Addendum 2

February 22, 2019

Master Food, Beverage, and Retail RFP

OKALOOSA COUNTY, FL
OUTDOOR CONCESSIONS AREA
 DESTIN - FT. WALTON BEACH AIRPORT

Concept for ~700SF outdoor concessions space

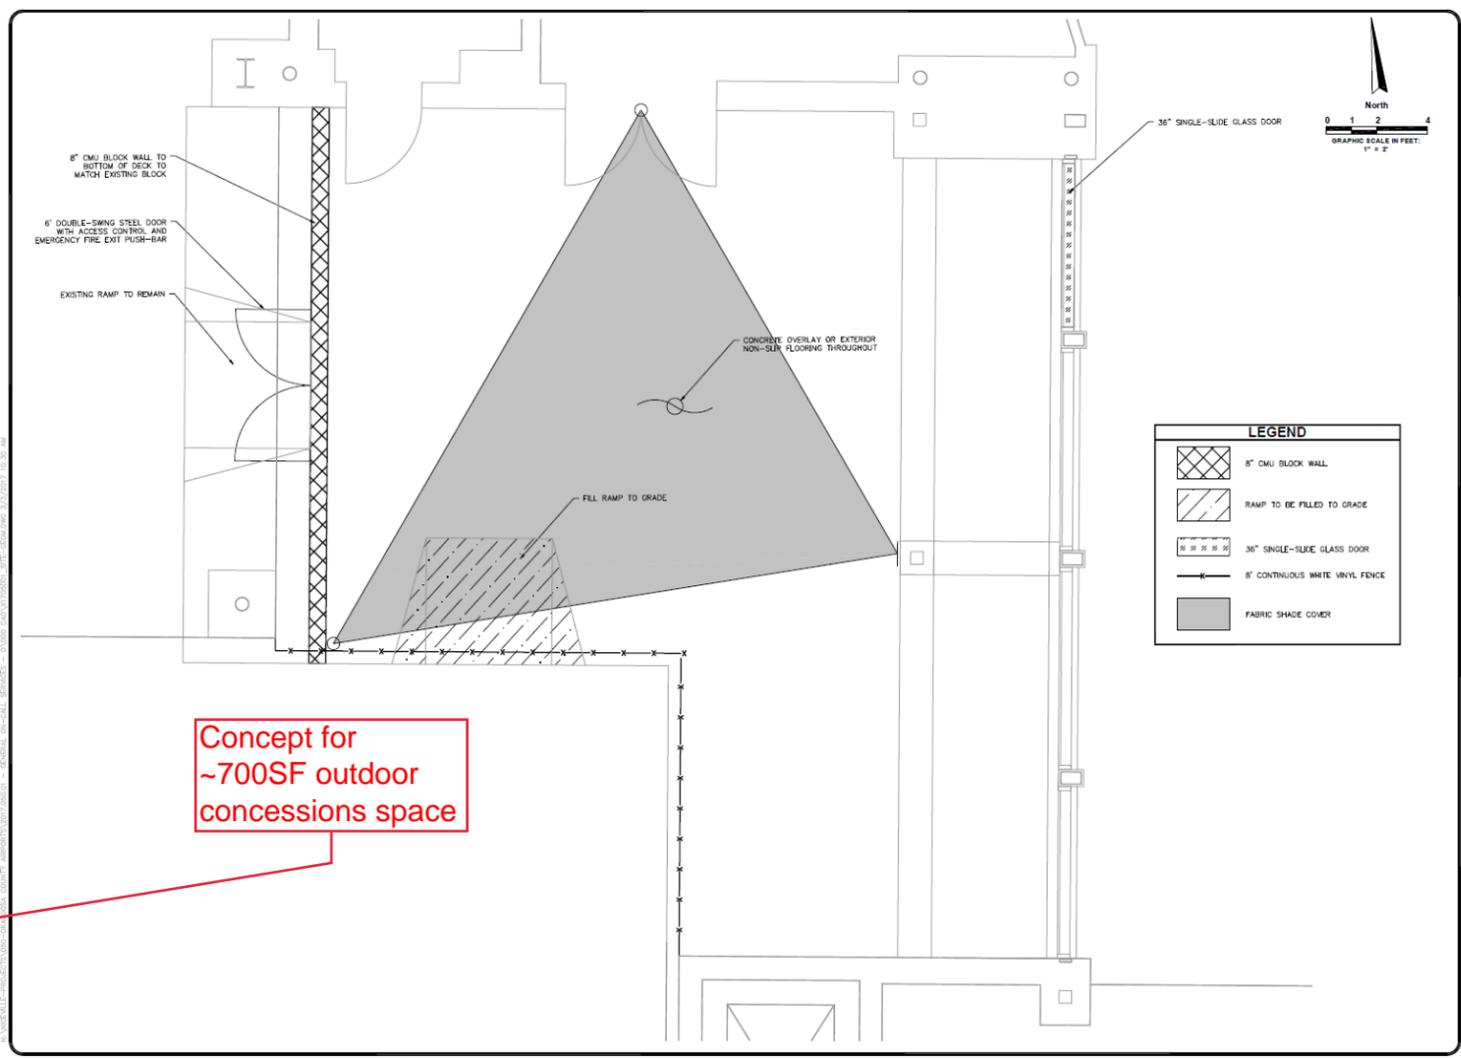
12. What is the airports ADCBR participation goal on this contract? **Response:** The recommended ACDBE participation goal is 0.95%.
13. Estimated Square footage of the proposed outdoor space? **Response:** The attached schematic drawing identifies the potential space. Based on this concept, approximately 700SF. Note: This space is optional, and it is up to the Respondent to determine if this is a desired investment.

14. Will the airport secure the space to meet TSA standards? **Response:** All improvements will be the responsibility of the Contractor.
15. Will the airport provide water to the space? **Response:** No, the County will not provide water. The successful Respondent will need to run water to the site if required.

16. Are drains available for waste water? **Response:** No drains are currently available.

17. Will the airport provide electrical to the space? **Response: No. The space is available as an option for the successful Respondent and if the successful Respondent desires to use the space, all improvements will be the responsibility of the successful Respondent.**

18. Can the outdoors be non-smoking or is it a requirement that smoking be allowed? **Response: It is anticipated that this would be a seating area where smoking is allowed. Airport management will make final determination after appropriate research is performed regarding codifications and regulations.**

20. Please provide LODs for all spaces (including the outside patio smoking area and updated LOD for the B4/B6 space showing where the columns will be located specifically.) **Response: The potential area for the outside seating is approximately 700SF. After reviewing the layout of the Gate B5/B6 footprint for the concession space will remain "as is" as identified in the exhibits.**
